**Standardization of Small Generator
Interconnection Agreements
& Procedures**

Docket No. RM02-12-000

**SUPPLEMENTAL JOINT FILING OF PUBLIC INTEREST ORGANIZATIONS
& SMALL RESOURCE ADVOCACY GROUPS (“Small Generator Coalition”)
ON THE SMALL GENERATOR INTERCONNECTION NOPR
(October 8, 2003)**

SGC Joint Comments – Attachment: DIAGRAMS

Chart 1: NOPR Interpretation

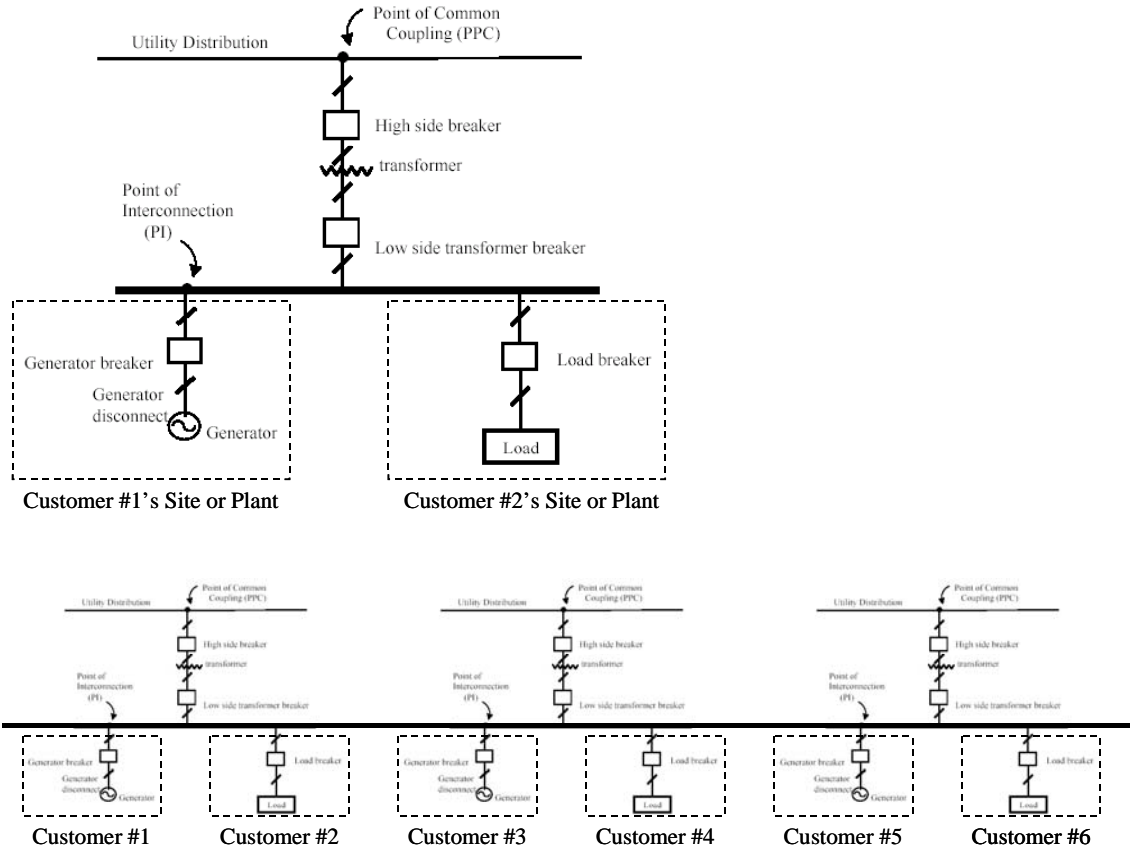
115. Please see the attached set of 4 diagrams. The first diagram shows the current Chart 1 in the NOPR. The second diagram shows the original diagram submitted in the ANOPR consensus document. Diagrams 3 and 4 show the technically correct chart, one where the customer owns the service transformer, and the other with the EPS operator owning the transformer. It is comparatively irrelevant which of these two diagrams is used. The first situation is more common in smaller installations such as commercial buildings, and the latter is more common with large customers such as industrial plants.
